# DU MONT

**SERVICE NOTES**

**DU MONT TELESETS**

RA-103C

### Trap Assembly:

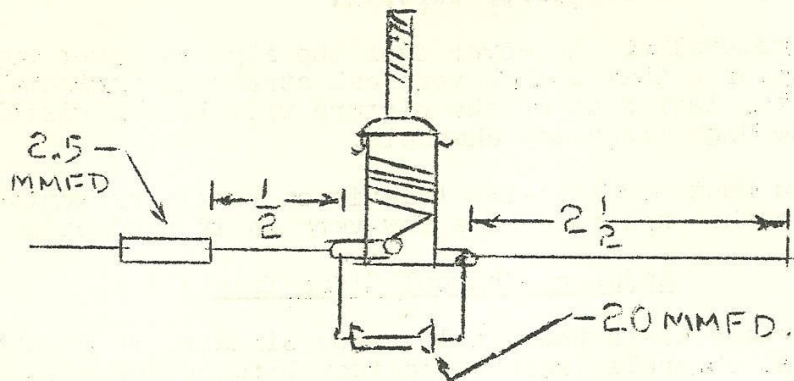
This may be corrected in the field, by the addition of a series-parallel resonant trap in the third video IF amplifier as illustrated in the sketch below:

The parts required are one 2.5 uuf, part #03014570, one 20 uuf, part #03013800 and one inductor assembly, part #21004491. Connect the 2.5 uuf capacitor to the lug to which the end of the winding closest the lug is soldered, leaving  $\frac{1}{2}$ " of wire between the body of the capacitor and the lug.

Connect a  $2\frac{1}{8}$ " length of #18 bare-tinned copper wire to the other lug of the inductor. Connect the 20 uuf capacitor across both of the lugs of the inductor.

### Installation:

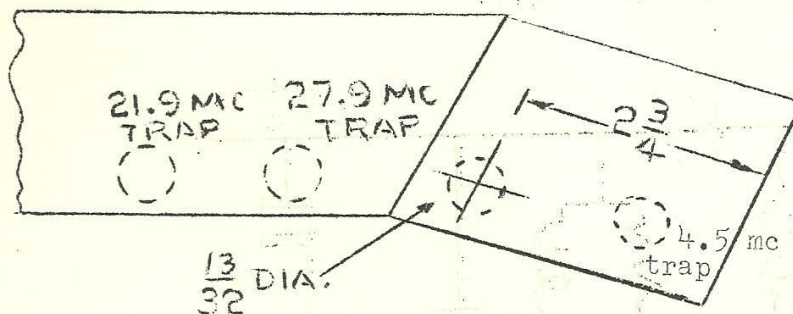
A  $\frac{13}{32}$  diameter hole should be carefully punched (using a Parker-Kalon Metal Punch XX) in the video IF amplifier shield plate as shown in the sketch below:

Use extreme caution when punching this hole so that alignment will not be disturbed.

Insert the trap assembly in the hole so that the lugs are parallel to the main chassis, and with the bare wire closest to the main chassis. Solder the bare-tinned wire to pin 3 of the video amplifier (V205). Solder the free end of the 2.5 uuf capacitor to the junction of L212, C288, R218, and Pin 2 of V204-A.

Fig. 1A OLD CIRCUIT

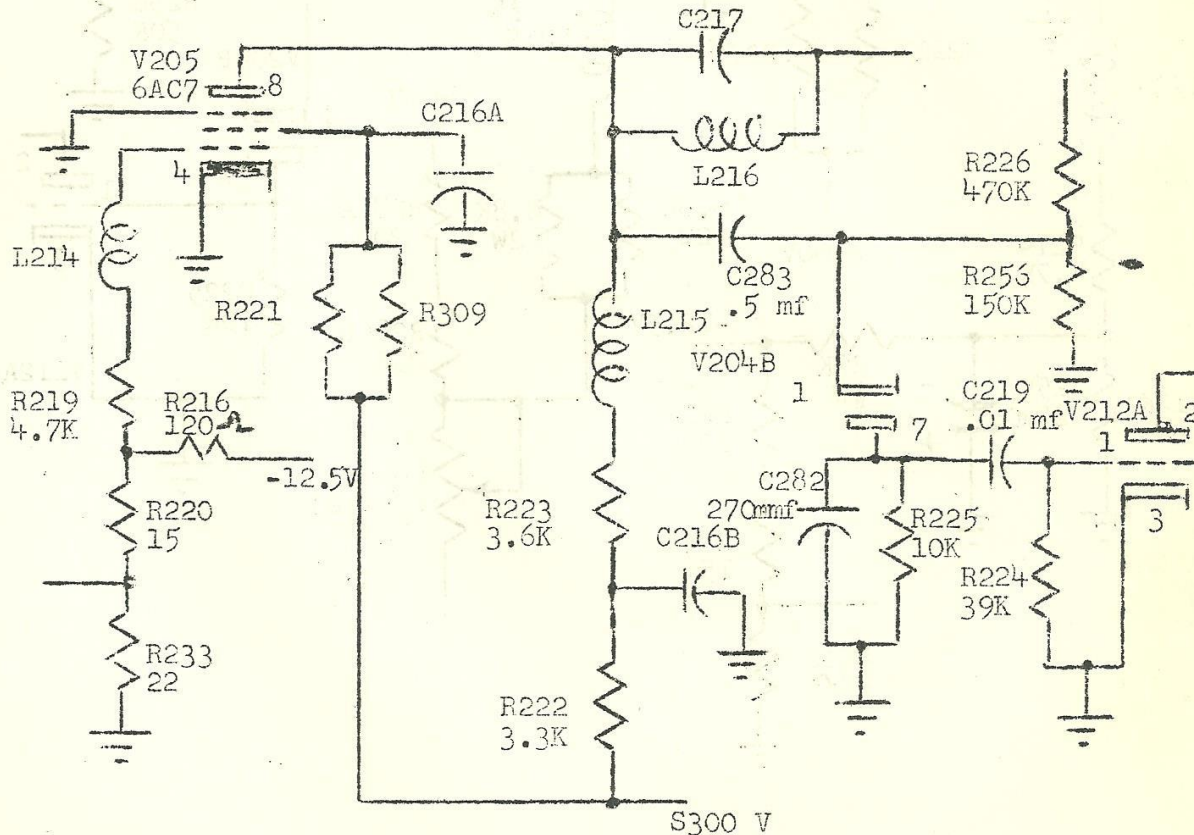
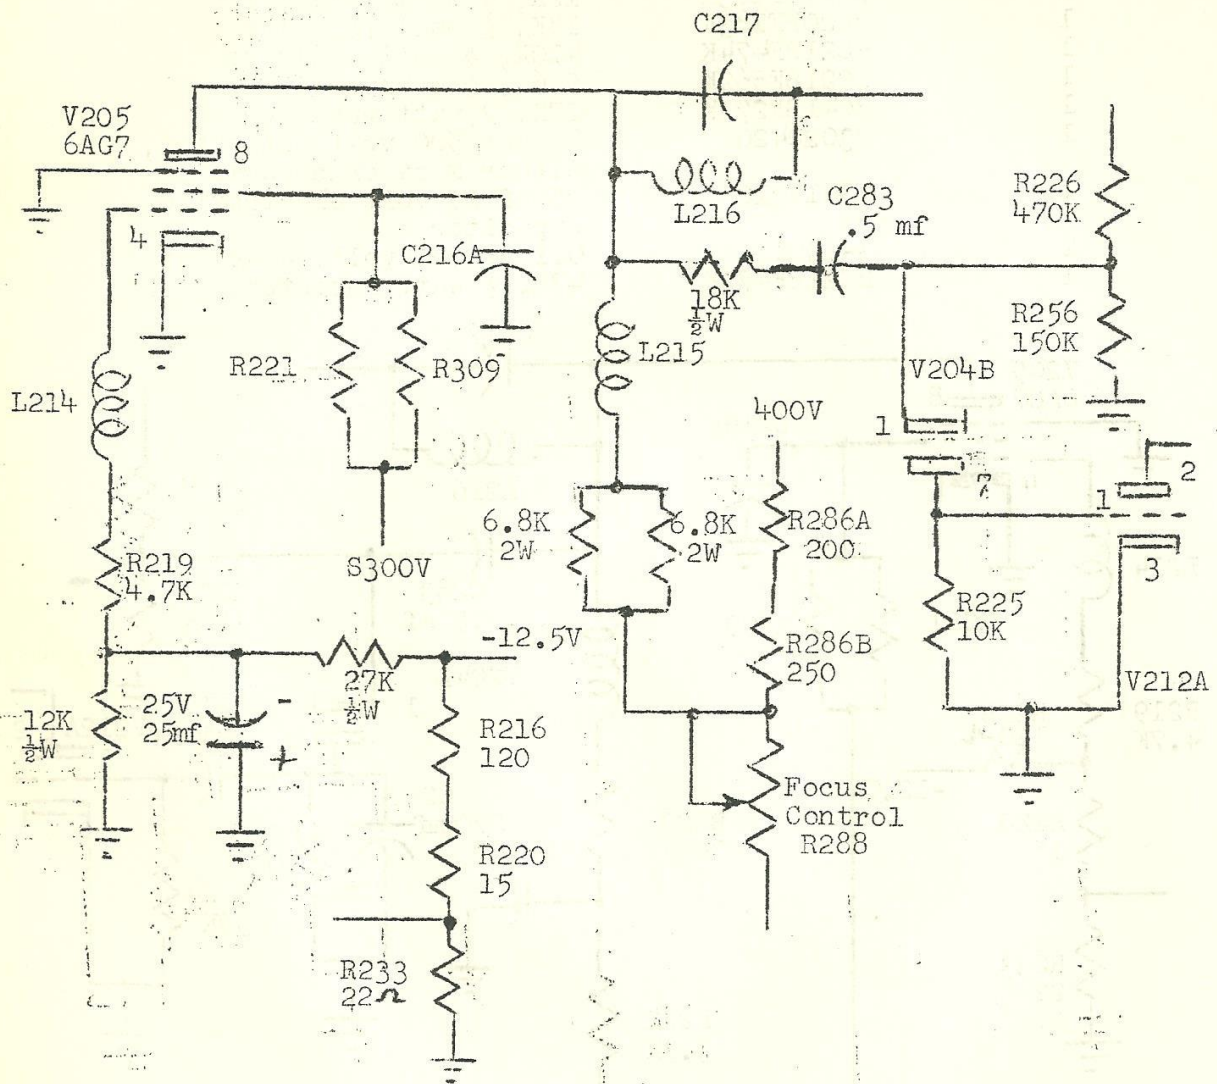
Refer to Fig. 1A showing the old or unmodified circuit and Fig. 1B showing the new or modified circuit when making the following changes:

1. Replace V205 the 6AC7 Video amplifier tube with a type 6AG7 tube.
2. Disconnect the low side of R219 (the 4.7K resistor in the grid circuit of V205) from the junction of R216 (120 $\Omega$ ) and R220 (15 $\Omega$ ).
3. Connect a 12K  $\frac{1}{2}$  watt resistor from the low side of R219 (just disconnected) to ground. Place a 25 mfd 25V capacitor in parallel with this resistor. Be sure to connect the positive side of the capacitor to ground.
4. Add a 27K  $\frac{1}{2}$  watt resistor between the junction of R219 (4.7K) and the 25mfd capacitor and 12K resistor added in step 3 and the junction of the -12.5 volt line and R216.

5. Remove R223 (3.6K) (the plate load resistor of the video amplifier) and replace with the two 6.8K 2 watt resistors connected in parallel. Connect one end of this combination to the low end of L215 and run a lead from the other end of this combination to the junction of R288 (the focus control) and R286B (the candohm strip resistor).
6. Remove R222 (3.3K, connected to C216B).
7. Add an 18K  $\frac{1}{2}$  watt resistor between the junction of L215, C217 and L216, and capacitor C283.
8. Remove capacitor C282 (connected from pin #7 V204B to ground). Remove capacitor C219 (located between pin #7 of V204B and pin #1 of V212A) and replace with a short lead, using pin #7 terminal lug to which C219 was connected.
9. Remove resistor R224 (located between pin #1 of V212A and ground).

Fig. 1B NEW CIRCUIT

Fig. 2A OLD CIRCUIT

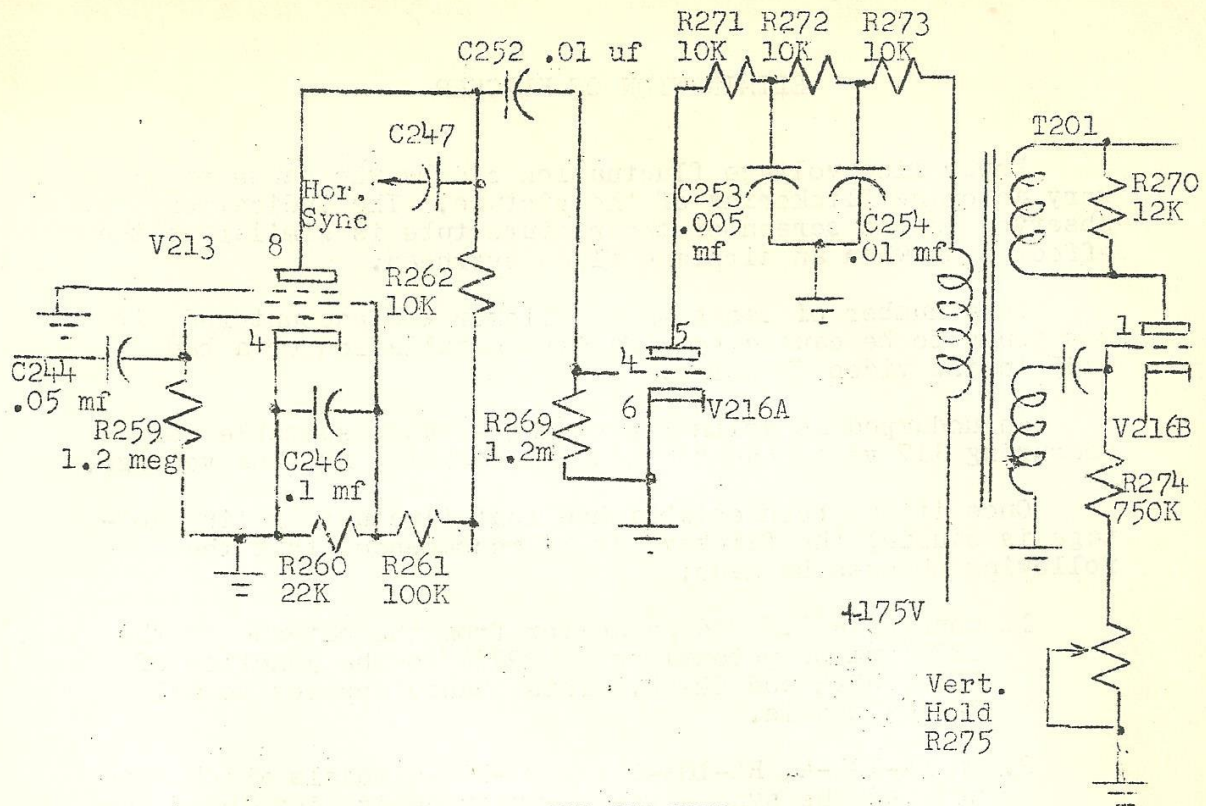
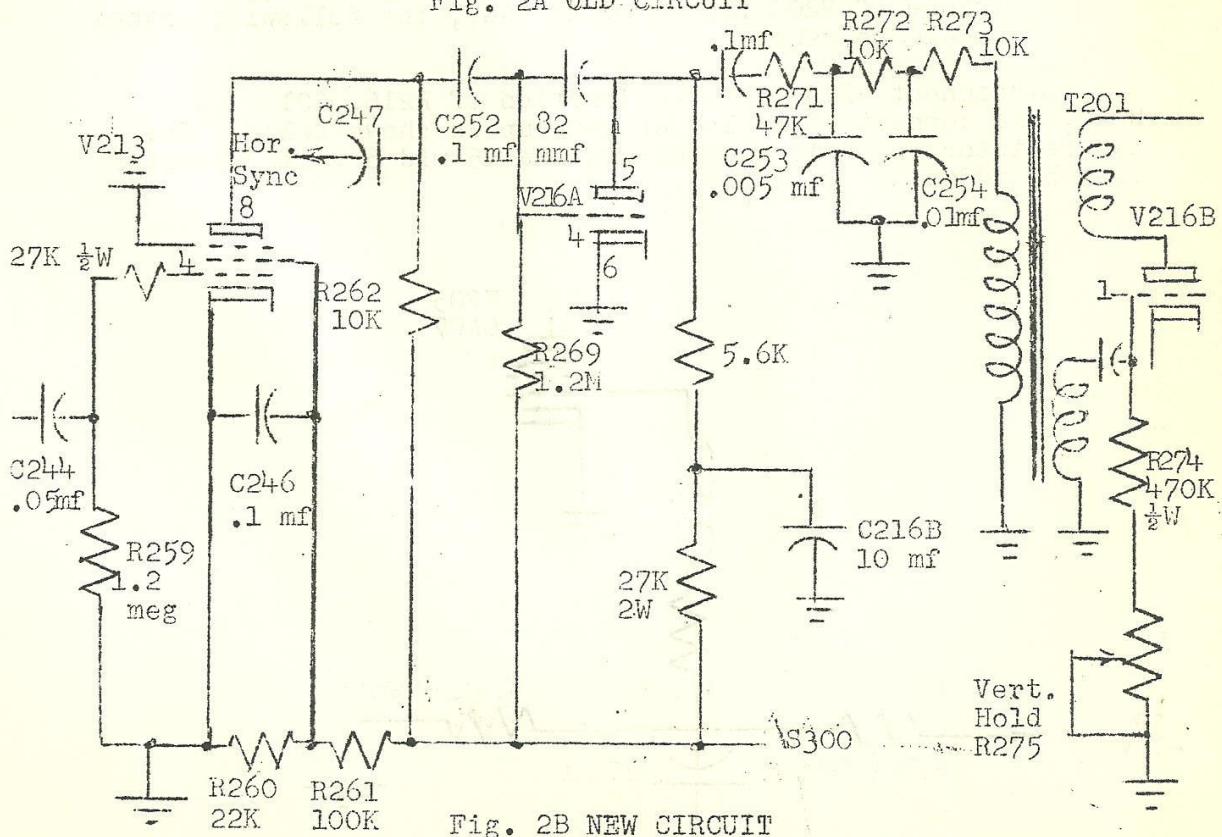
Refer to Fig. 2A showing the old or unmodified circuit and Fig. 2B showing the new or modified circuit when making the following changes:

10. Add a 27K  $\frac{1}{2}$  watt resistor between the junction of C244 and R259 and pin #4 of V213.
11. Remove capacitor C252 (between pin #8 V213 and pin #4 V216A) and replace with 0.1 mf capacitor.

12. Disconnect the ground side of R269 (grid circuit of V216A). This will be connected in step #17.
13. Connect an 82 mmf capacitor between pins #4 and #5 of V216A.

14. Disconnect R271 (10K) from pin #5 of V216A. (This resistor will be replaced in step #18).
15. Connect a 5.6K  $\frac{1}{2}$  watt resistor to pin #5 V216A.

16. Connect the other end of the 5.6K resistor just added to a 27K 2 watt resistor. Run a lead from the junction of these two resistors to C216B.
17. The other end of the 27K 2 watt resistor is to be connected to the junction of R262 and R261 and to the low side of R269 the 1.2M resistor in the grid circuit of V216A.

18. Replace R271 with a 47K  $\frac{1}{2}$  watt resistor.
19. Connect a .1 mfd capacitor between pin #5 of V216A and the 47K just added.
20. Disconnect the blue lead of the primary of T201 from the +175 volt line and run directly to ground.

21. Remove R270 (the 12K resistor connected across the Brown Black winding of T201)
22. Remove R274, the 750K resistor located between pin #1 of V216B and the vertical hold control and replace with a 470K  $\frac{1}{2}$  watt resistor.

Fig. 2B NEW CIRCUIT

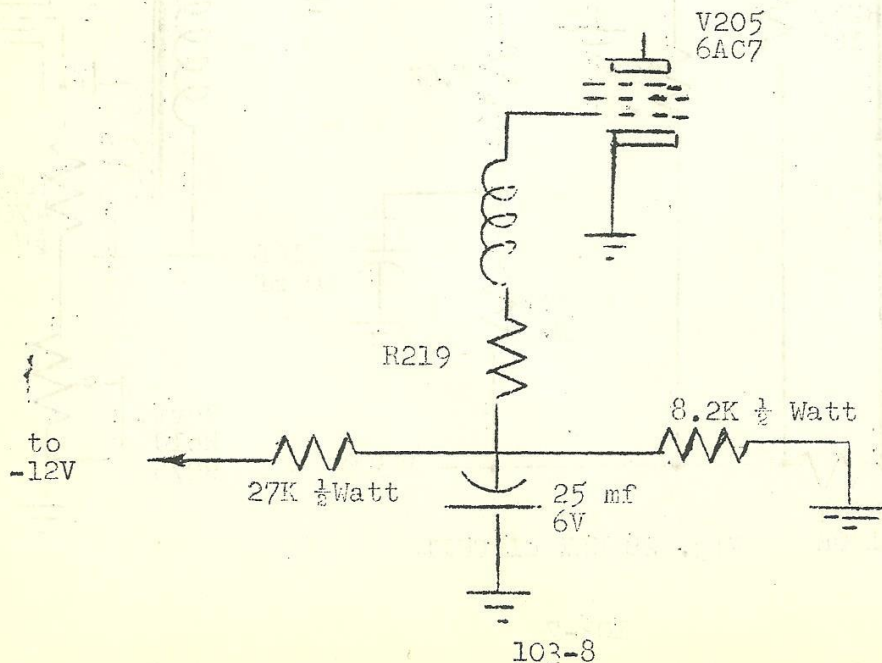
Once it has been established that fluctuating line voltage is causing the flicker, it is recommended that the following changes be made:

1. Connect a 0.5 mfd capacitor from the cathode of the CRT (arm of potentiometer R227) to the junction of R222, R223 and C216B. This change applies to all RA-103 models.
2. On RA-103-A, RA-103-B and RA-103-C models which have not had the sync noise immunity change involving the change of V205 from 6AC7 to 6AG7, the following change should be made:

Disconnect R219 from the junction of R216, C215 and R220, and connect to a bleeder made up as shown below. The two resistors of this bleeder and the 25 mfd 6 volt capacitor must be added.
